### **ADDENDUM NO. 2**

## **Hopewell Phase I East Infrastructure – Re-Bid**

**Issued From:** The City of Bloomington

**Issue Date:** April 28, 2023 **Letting Date:** May 3, 2023

SIGNAGE AND PAVEMENT MARKING PLAN

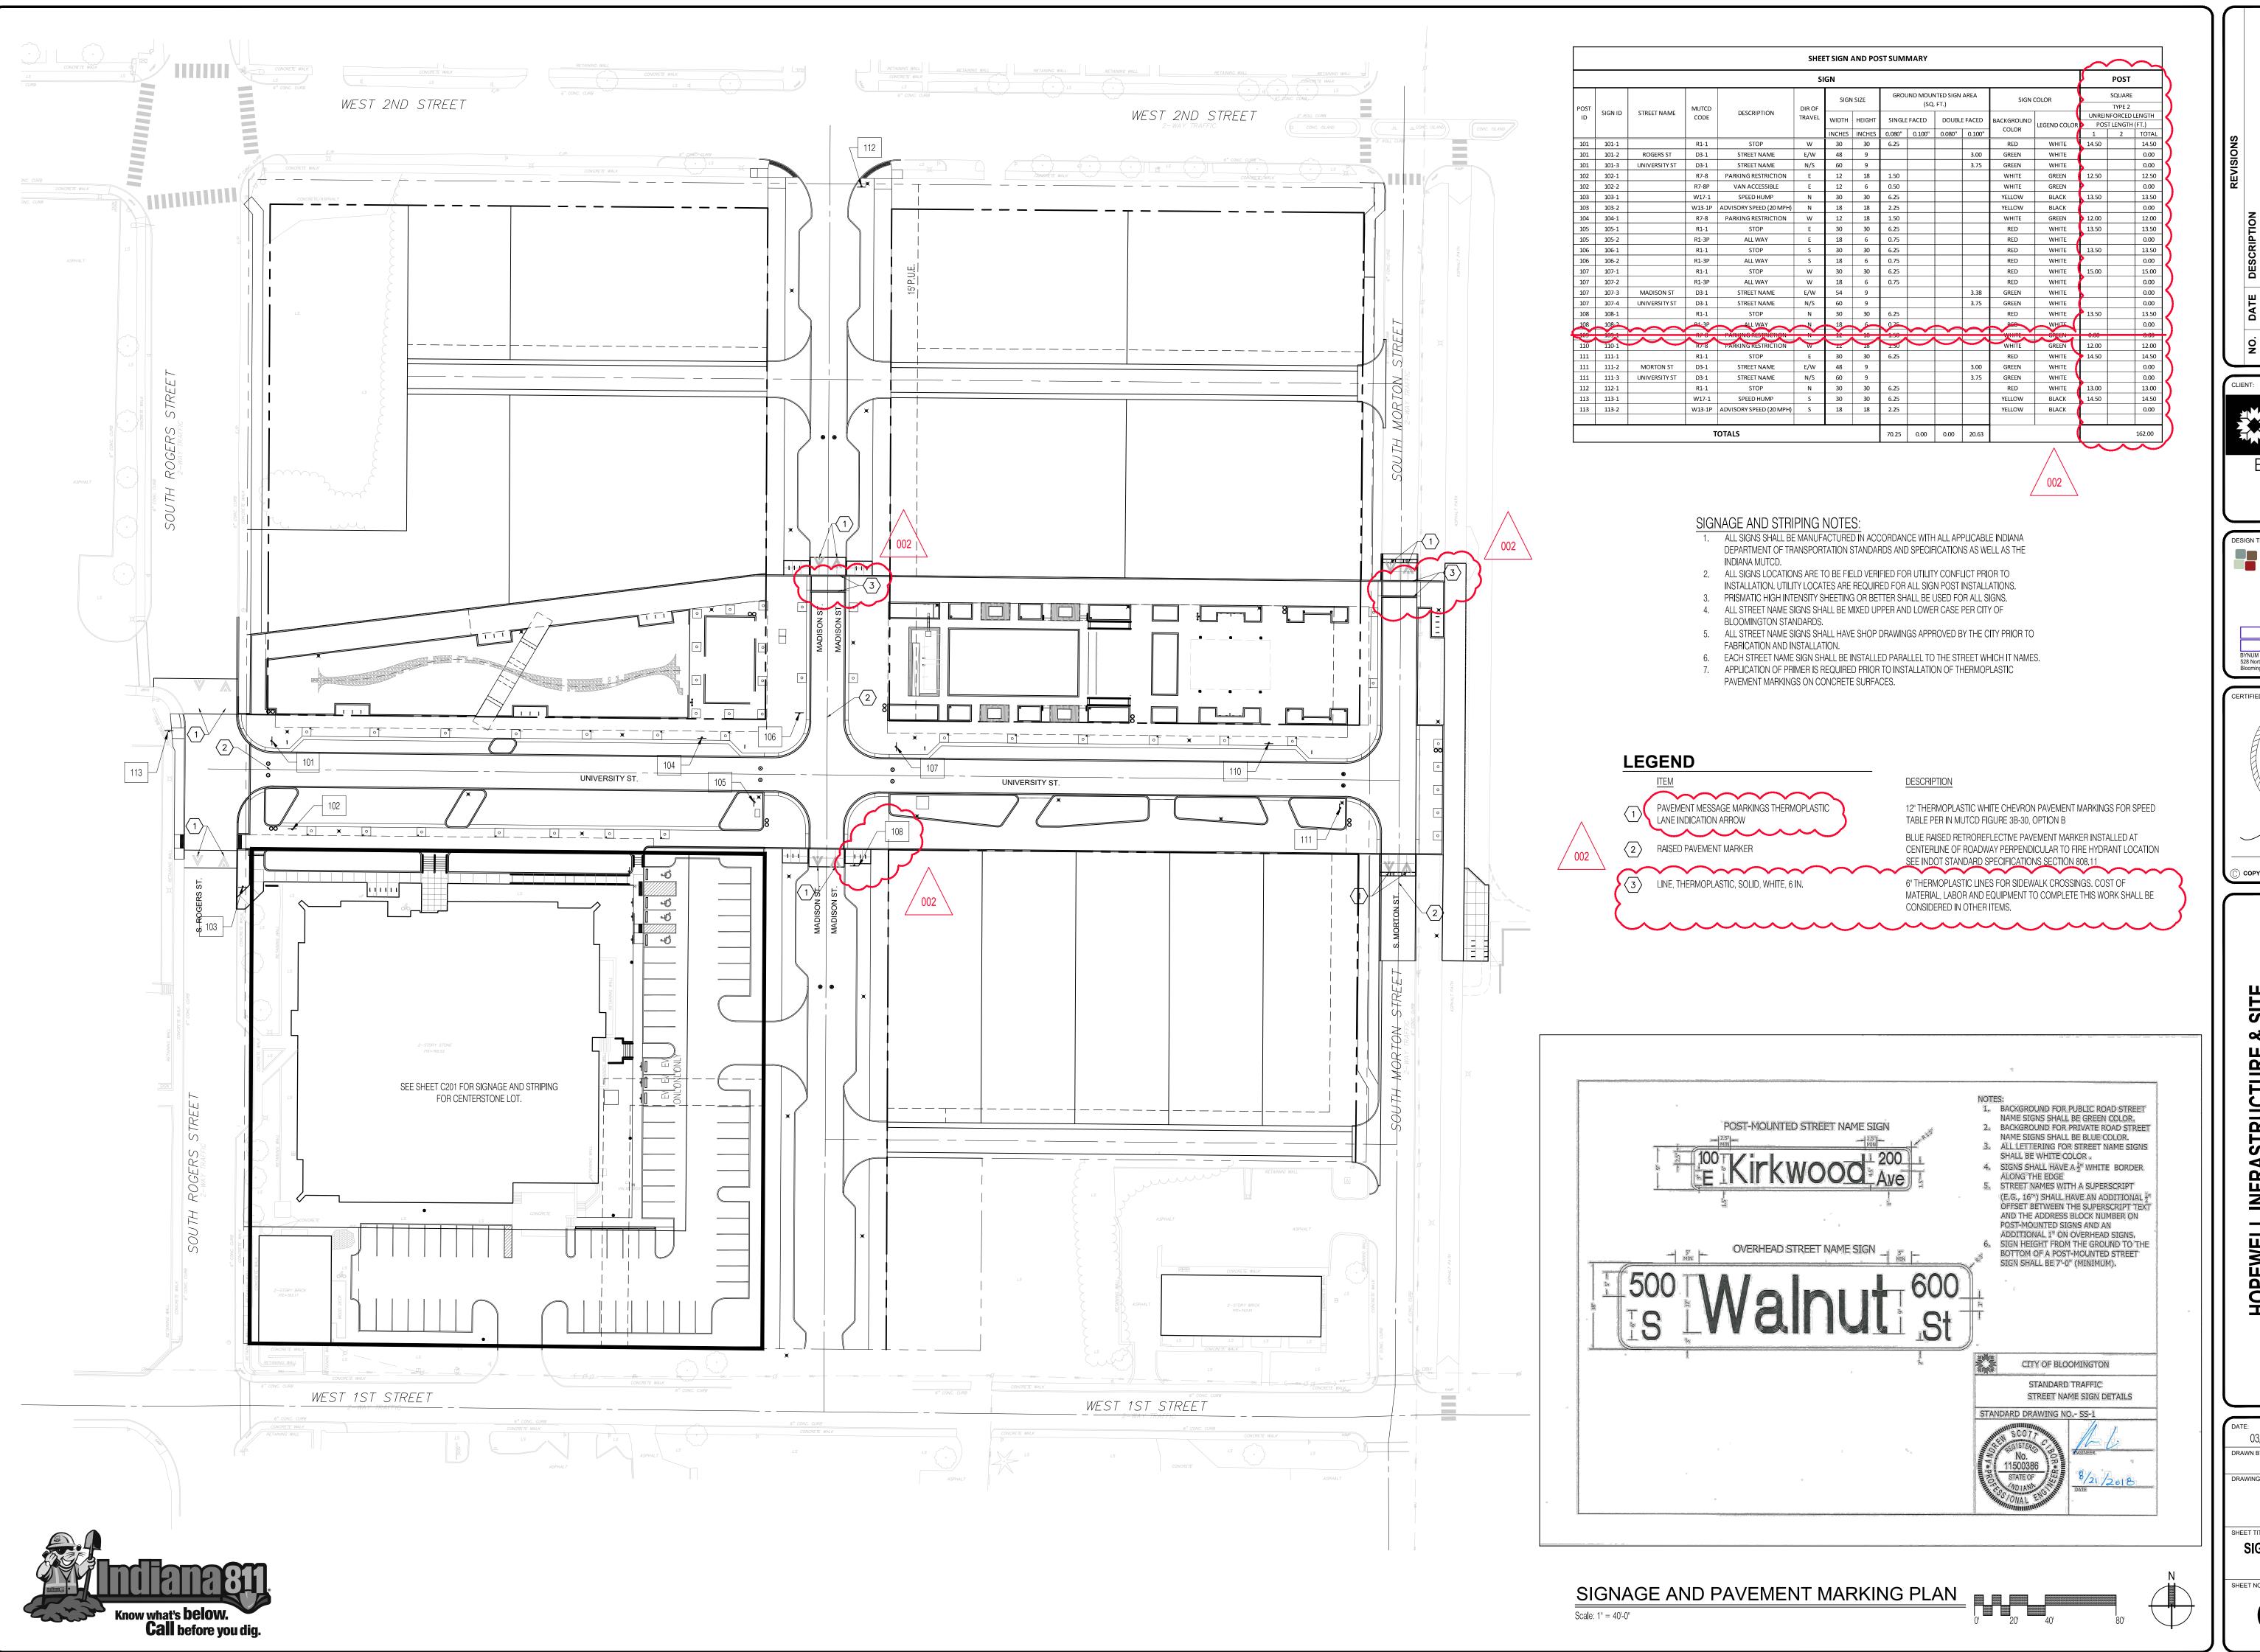
Drawing: C102B - Signage and Pavement Marking Plan

**<u>DELETE</u>** existing sheet Plan C102B – Signage and Pavement Marking Plan in its entirety and **<u>INSERT</u>** attached revised sheet C102B – Signage and Pavement Marking Plan.

PROJECT NO.: 03/15/2023 21-0049 CHECKED BY: RDR MDW **RE-BID CENTERSTONE SITE DETAILS**

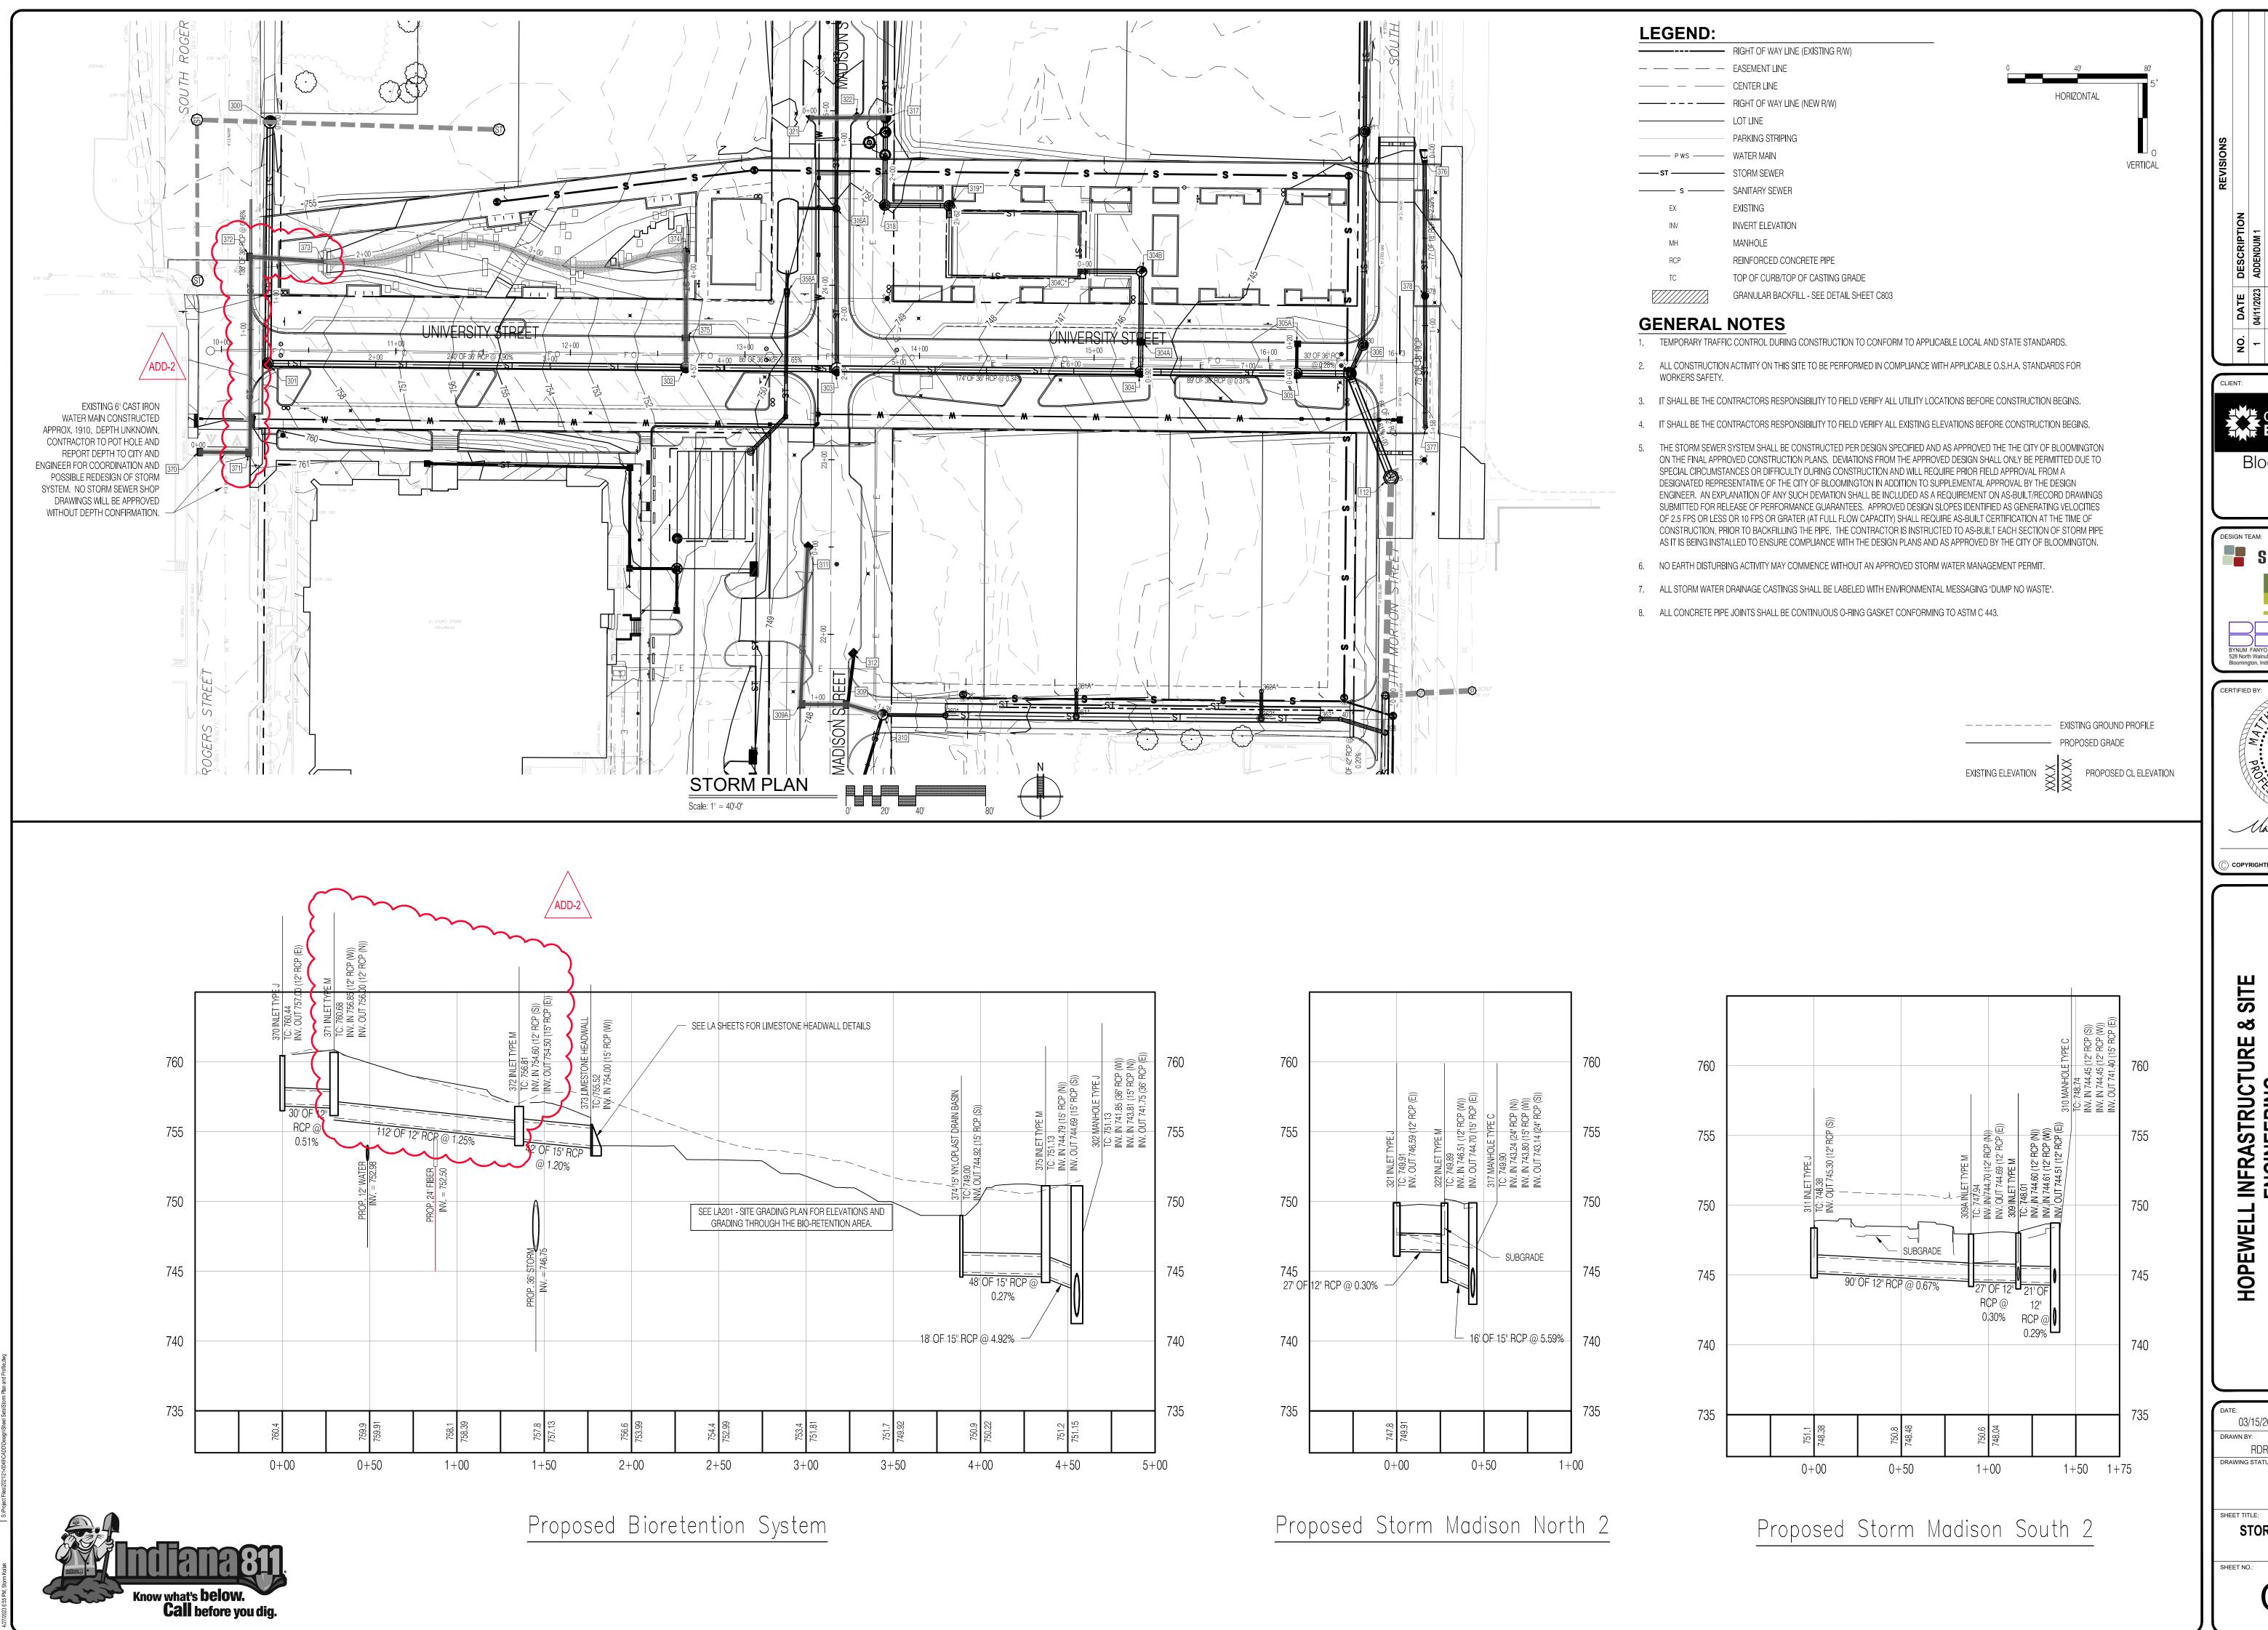
Drawing: C210 – Centerstone Site Details

**<u>DELETE</u>** existing sheet C210 – Centerstone Site Details in its entirety and **<u>INSERT</u>** attached revised sheet C210 – Centerstone Site Details.
